Re: 120-128 Herring Road, Macquarie Park MP09_0217

After review of the Project Approval conditions and the associated documentation we have found a minor dimensional inconsistency upon the Stage 2 Subdivision Plan.

The new plan set for each Stage have been annexed to this letter, both Sets are now known as Revision 8 with a print date of 8TH March 2011

Surveyor: CAMERON PHILLIP MILES Date of Survey: 05/01/2010 Surveyor's Ref: 091120.DP.STG1A	PLAN OF SUBDIVISION OF LOT 1 IN D.P._____ STAGE 1A	LGA: RYDE Locality: MACQUARIE PARK Subdivision No: Lengths are in metres. Reduction Ratio 1: 750	REGISTERED	DP
--	---	---	------------	----

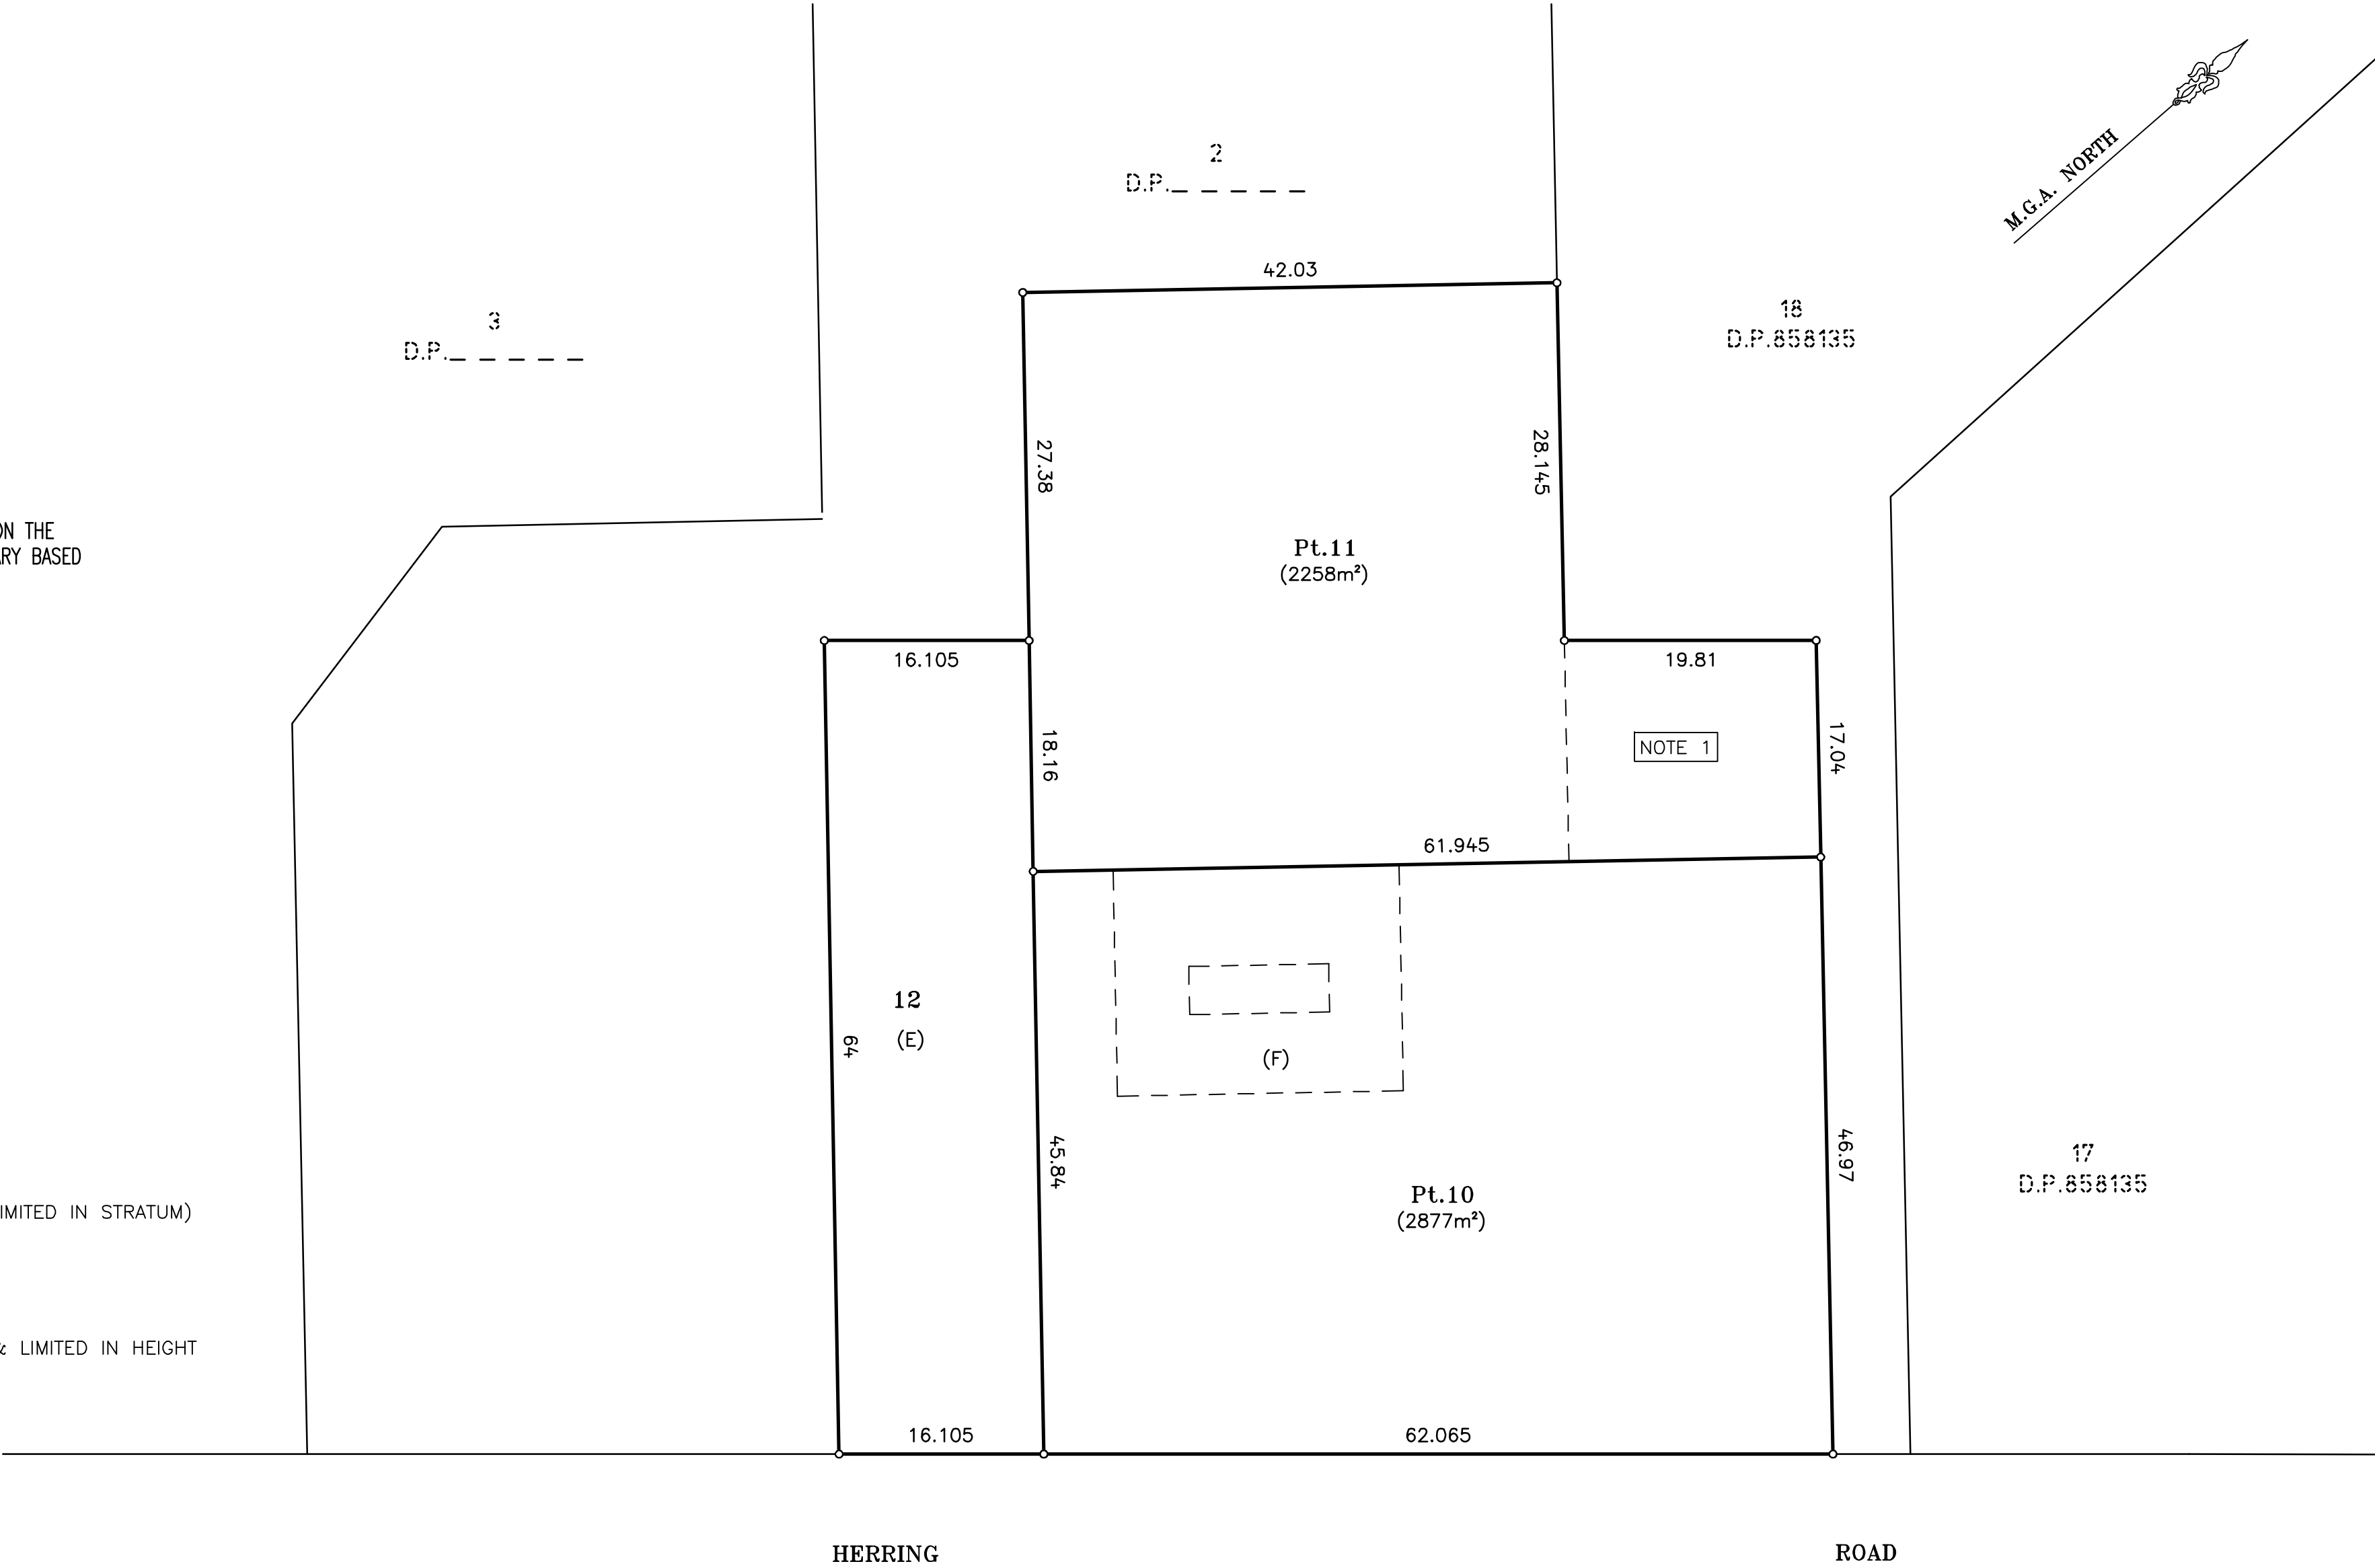
As requested by Lipman we have also modified the wording to the pedestrian and Cyleway easement upon the Stage 1A plan. This easement was previously referred to as a "Right of Footway Variable Width (X)". The easement is now to be known as an "Easement for Access (Pedestrian & Bicycle) 2.5 wide (X)"

EASEMENTS:
(E) EASEMENT FOR ACCESS (WHOLE OF LOT)
(X) EASEMENT FOR ACCESS (PEDESTRIAN & BICYCLE) 2.5 WIDE
LOTS 10 & 11 ARE STRATUM LOTS LIMITED IN STRATUM AS SHOWN ON SHEETS 2 & 3.

Surveyor: CAMERON PHILLIP MILES Date of Survey: 05/01/2010 Surveyor's Ref: 091120.DP.STG2	PLAN OF SUBDIVISION OF LOT 2 IN D.P._____ STAGE 2	LGA: RYDE Locality: MACQUARIE PARK Subdivision No: Lengths are in metres. Reduction Ratio 1: 750	REGISTERED	DP
---	--	---	------------	----

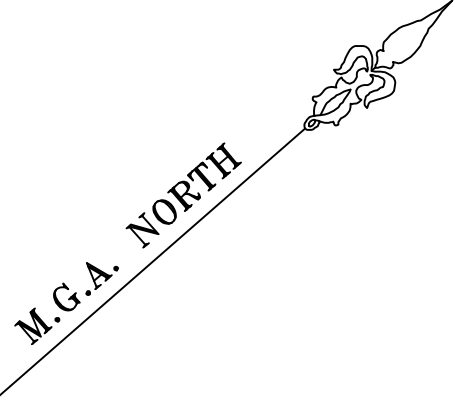
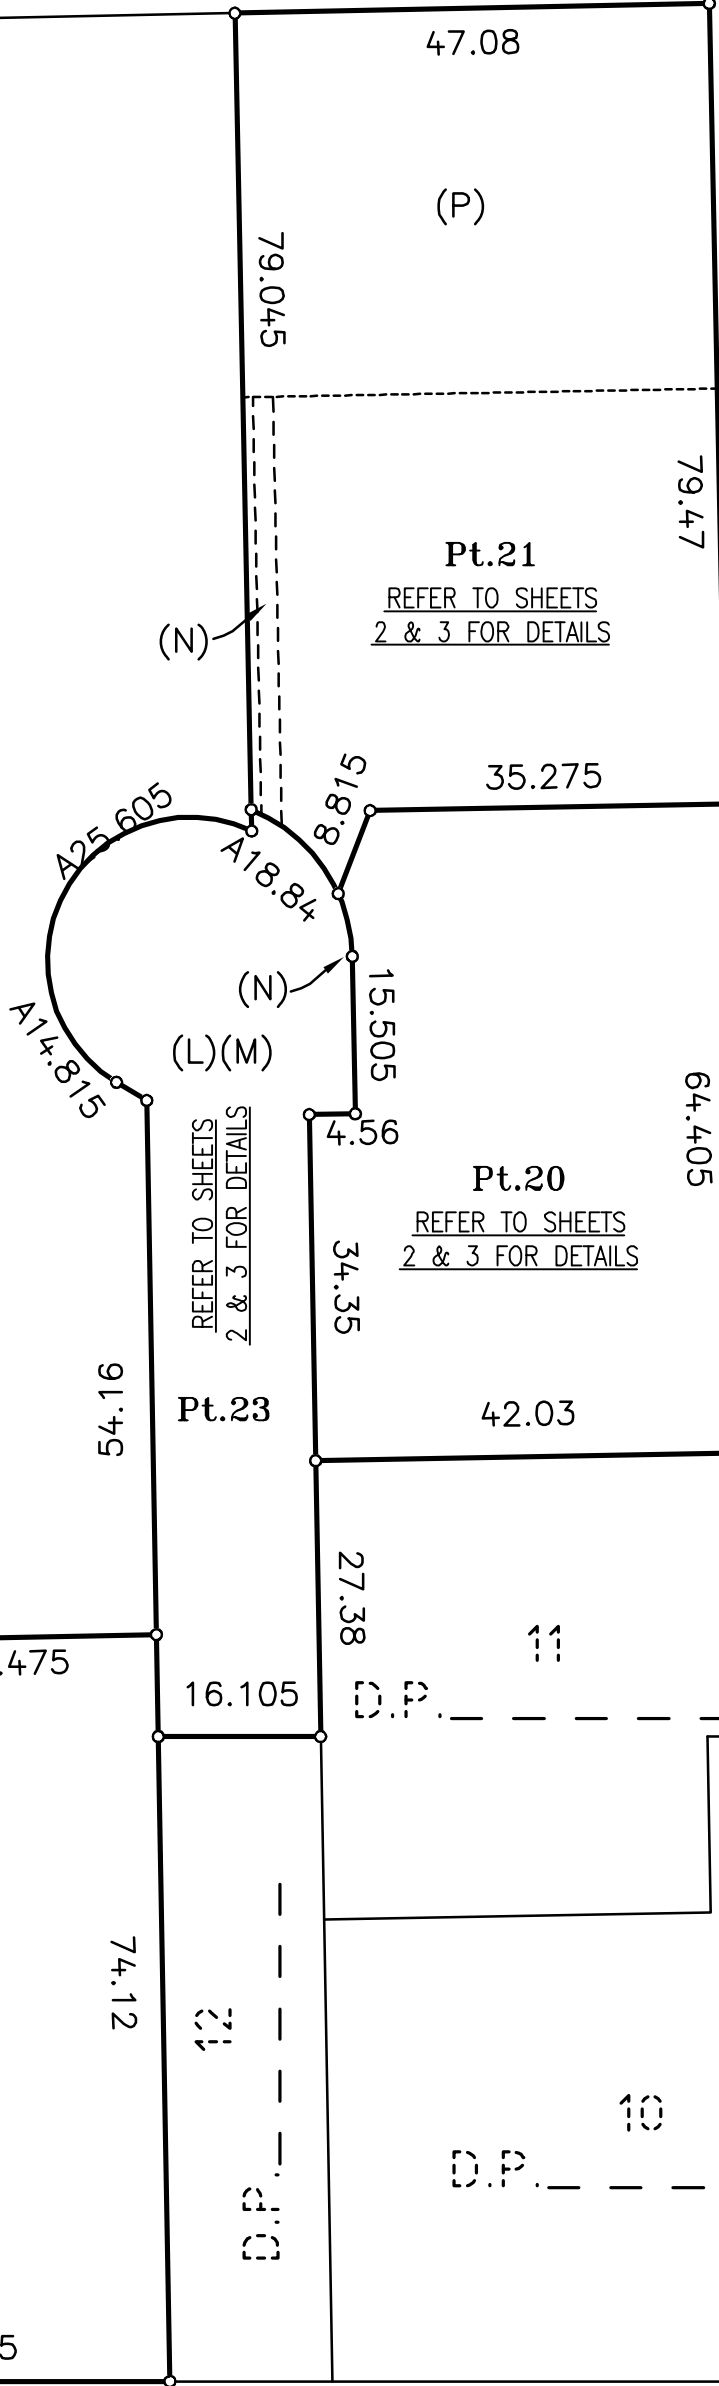
This inconsistency is upon Sheet 1 of the Stage 2 Plan, with the dimensions around the Cul-de-Sac head. The correct dimension, as previously shown on Sheet 3 remain unchanged . The areas of the associated parcels remain unchanged.
